<b>AMENDMENT OF SOLICITATION/MODIFICATION OF CONTRACT</b>			1. CONTRACT ID CODE	PAGE OF PAGES 1   3
2. MODIFICATION NO.:  0003	3. EFFECTIVE DATE  SEP 03, 2004	4. REQUISITION/PURCHASE REQ. NO.  W81W3G-2035-7181		PROJECT NO. (If applicable)
6. ISSUED BY Department of the Army Baltimore District, Corps of Engineers Contracting Division P.O. Box 1715 Baltimore MD 21203-1715	CODE CA31	7. ADMINISTERED BY: Contracting Division, Contracts Branch CENAB-CT-C 10 S. Howard ST. Room 7000 Baltimore, MD 21203-1715		CODE E1P0100
8. NAME AND ADDRESS OF CONTRACTOR (No., street, county, State and ZIP Code)			(x)	9A. AMENDMENT OF SOLICITATION NO. W912DR-04-R-0062
			X	9B. DATED (SEE ITEM 11) AUG 16, 2004
				10A. MODIFICATION OF CONTRACT/ ORDER NO.
				10B. DATED (SEE ITEM 13)
CODE	FACILITY CODE

**GENERAL PURPOSE WAREHOUSE, BUILDING 732  
DEFENSE DISTRIBUTION CENTER/DISTRIBUTION DEPOT SUSQUEHANNA PENNSYLVANIA (DDC/DDSP),  
NEW CUMBERLAND, PENNSYLVANIA**

AMENDMENT NO. 0003TO RFP W912DR-04-R-0062  
EFFECTIVE SEP 03, 2004

5) Sheet C1.1.3: Add General Note 12 as follows:

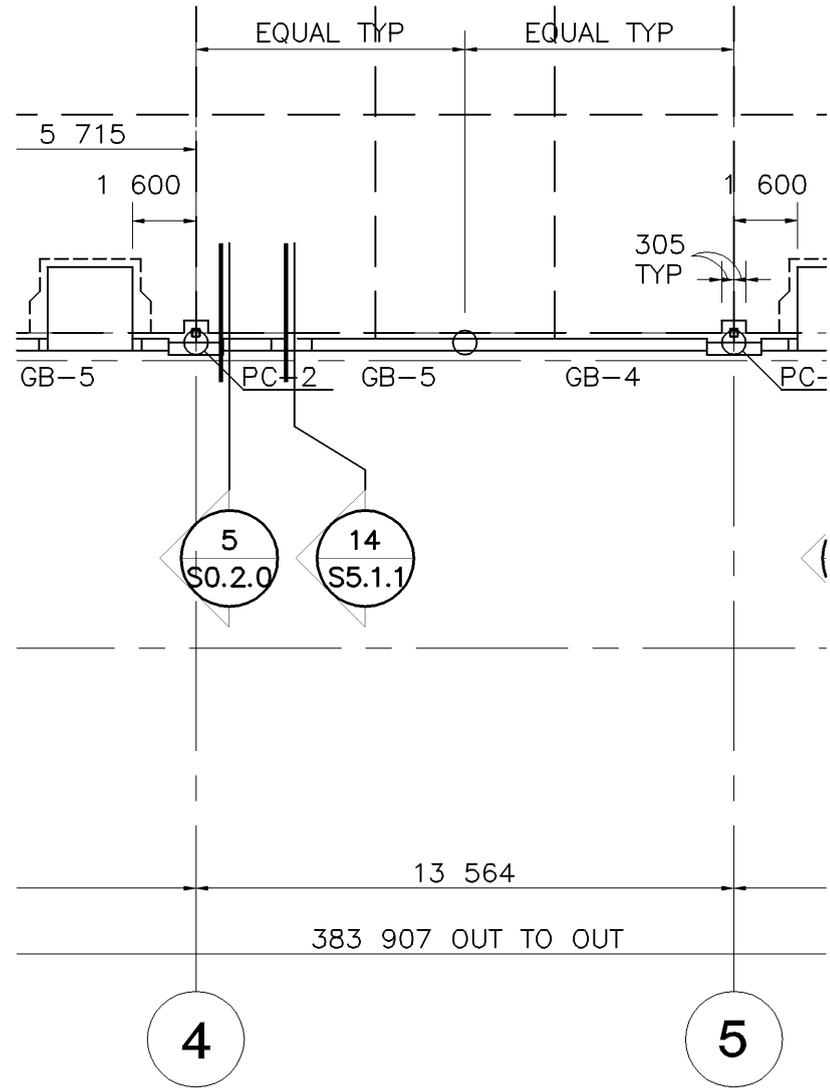
“12. The area delineated on the existing Building No. 2 site will not be available until January 2005. The contractor will be provided a limited reduced area to set up administrative/office trailers for the project duration along the Eastern side of Third Street. The contractor will be given access to an area approximately 150' (46 meters) x 40' (12.2 meters) between the steam manhole and the concrete drive. Upon completion of the project, the area will be restored to it's original condition.”
